UNITED STATES INSTITUTE OF PEACE
EXTERIOR DONOR RECOGNITION
23rd Street and Constitution Avenue, NW
Washington, D.C.

Delegated Action of the Executive Director

July 3, 2008

SITE KEY

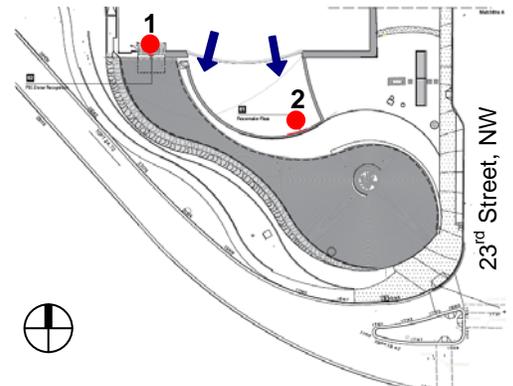
Staff has reviewed the proposal against NCPC's policy for exterior donor recognition, which generally dissuades from visible acknowledgements on museums, memorials, and cultural facilities; the intent is to prevent such acknowledgements from intruding on the integrity of the project or its environs. Analysis of the building design and programmed uses was undertaken, and it was determined that the planned headquarters building will function primarily as an office building and conference center, with only 17% of the areas (Public Education Center) dedicated for an ancillary cultural use. Therefore, staff finds that the proposal complies with NCPC's exterior donor recognition policy.

Staff also evaluated the proposal's potential impact to the Federal Image, which is protected through the *National Capital Image* policies included in the Preservation and Historic Features element of the Comprehensive Plan for the National Capital. After ongoing consultation with both NCPC and CFA staffs, and design revisions by the applicant, it is Staff's view that the resultant designs are of a high aesthetic standard that would neither detract from the Federal Image nor adversely affect any other identified federal interests.

Pursuant to delegations of authority adopted by the Commission on October 3, 1996 and 40 U.S.C. § 8722(b)(1) and (d), I approve the preliminary and final building plans for the exterior donor recognition at the United States Institute of Peace in Washington, D.C, as shown on NCPC Map File No. 1.33(38.00)42530.
